From: Yazon, Edwin
Sent: July 28, 2022 11:28 AM
To: Yazon, Edwin (CC) (Edwin.Yazon@gov.mb.ca)
Subject: FW: Steinbach Landfill Phase 2 Expansion
Attachments: MEM - Steinbach Phase 2 Design Memo.pdf

To:	Aaron Rach, Eldon Wallman	Date:	June 20, 2022
c:		Memo No.:	02
From:	Lauren Quan, William Wood, Kara Heckert, Paul Evans	File:	704-SWM.ONMB03157-01
Subject:	Phase 2 Landfill Design Memo

I have reviewed your submission requesting a phase 2 expansion of the Steinbach landfill. Please clarify/provide the following information:

PROJECT No. SWM.CNMB03157-01	OFFICE EDM	DES LQ	CKD WW	REV 0	DRAWING
DATE: June 2022	SHEET No. 4 of 6	DWN RT	APP LQ	STATUS B	C301

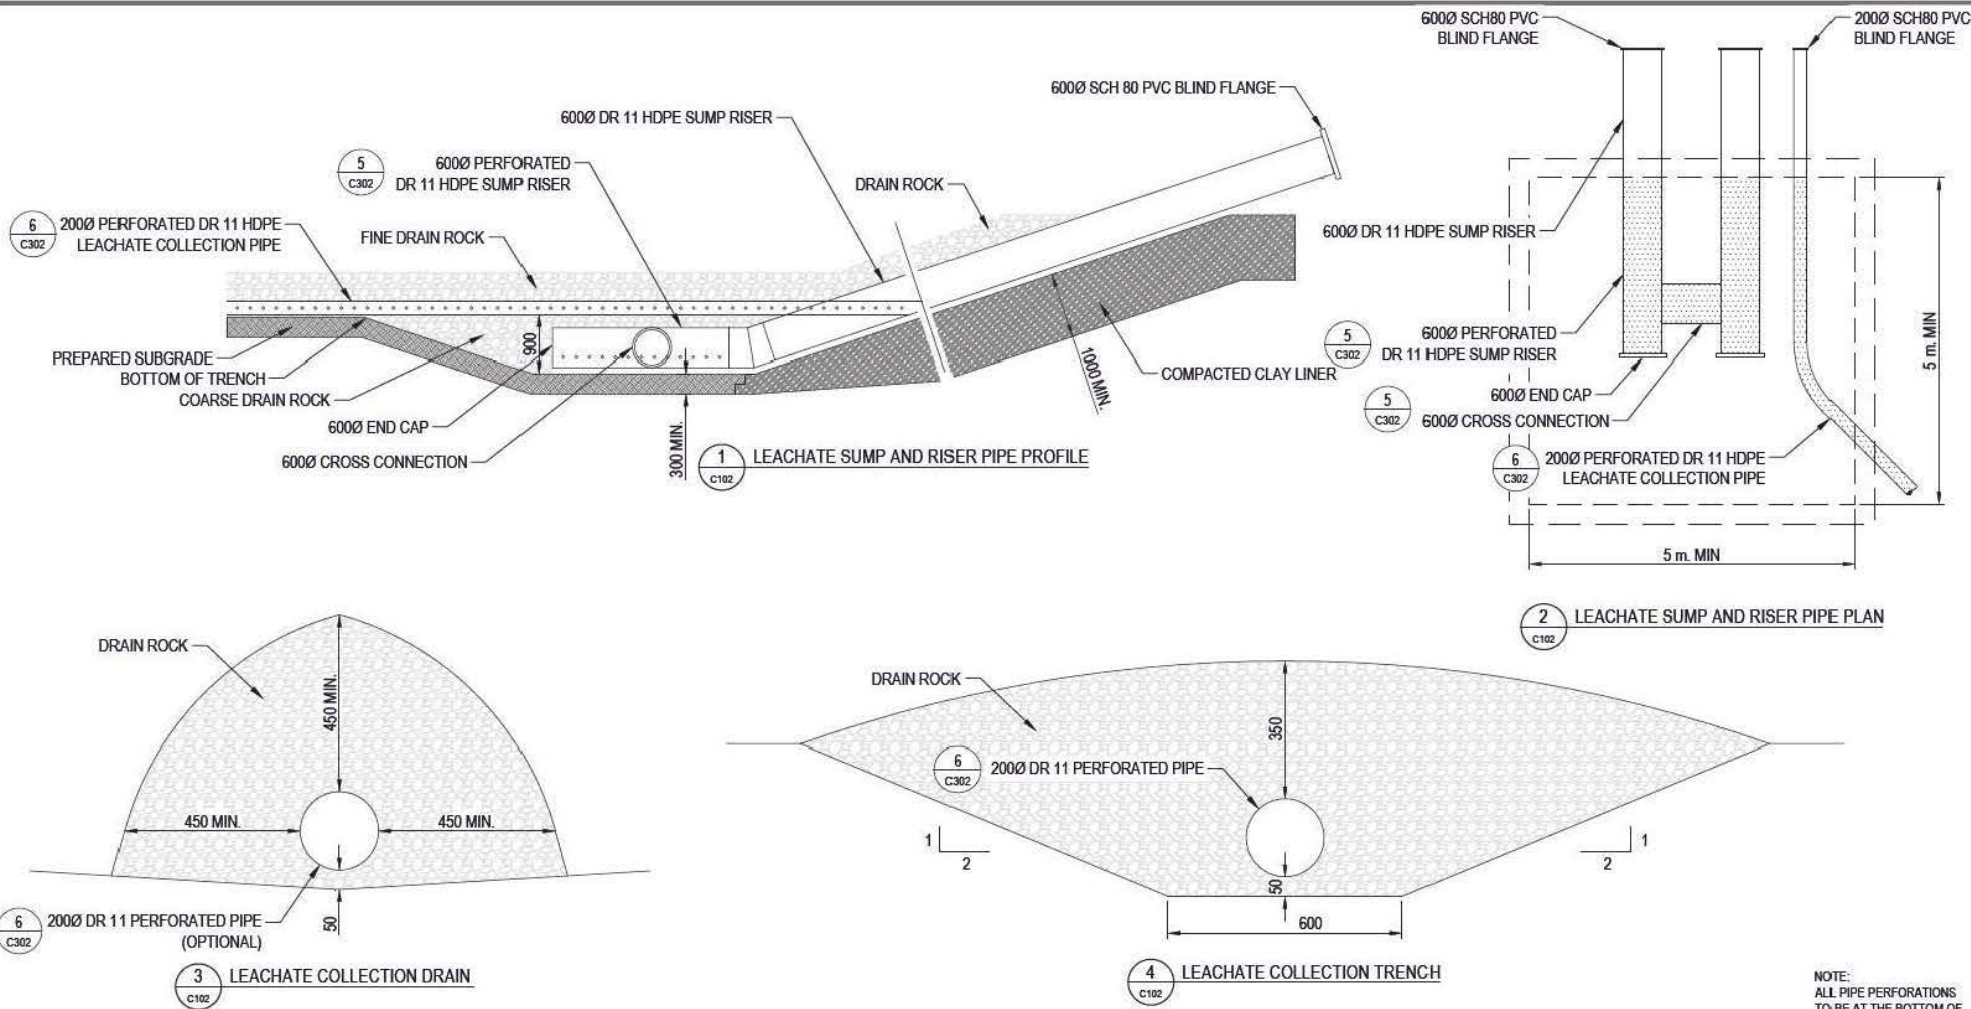
- Phase 2 expansion is designed with three leachate trenches with approx. 78 m spacing. The submission describes only two trenches – northern terminus and southern terminus trenches. Drawing 301 also indicates two trenches only.

**PHASE 2 EXPANSION SHOWING
PREVIOUS BORROW AREA**

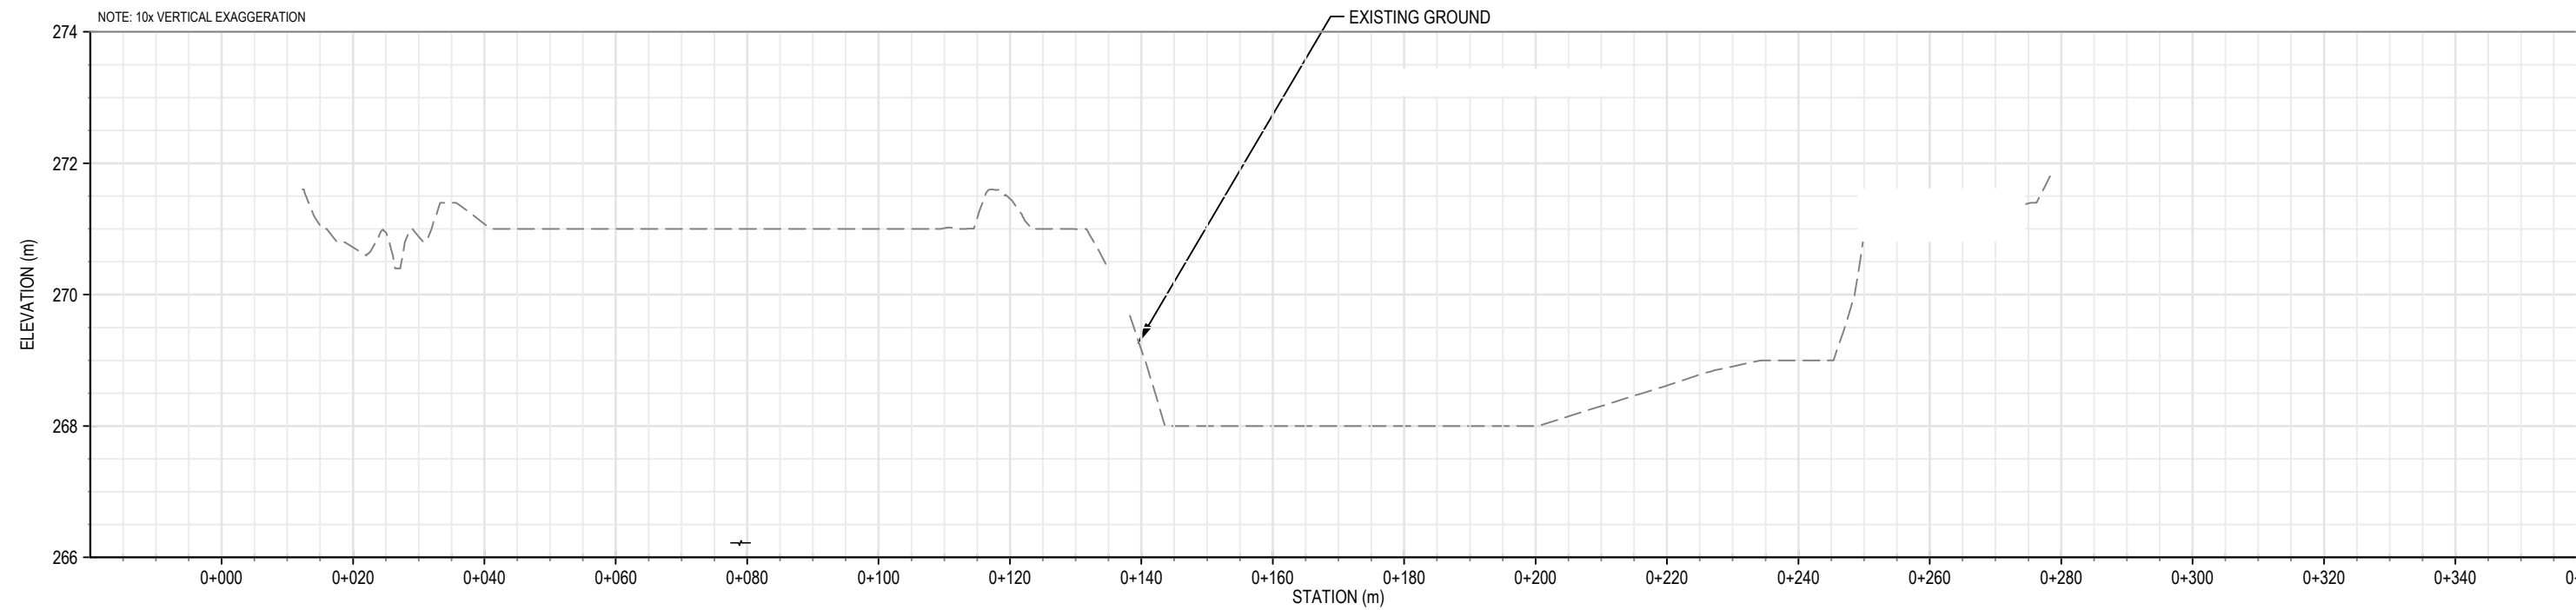
- Please include the borrow pit area in the drawing.
 - Approximate outline of the borrow pit is shown in the attached drawing. We can show this on the design set if needed.
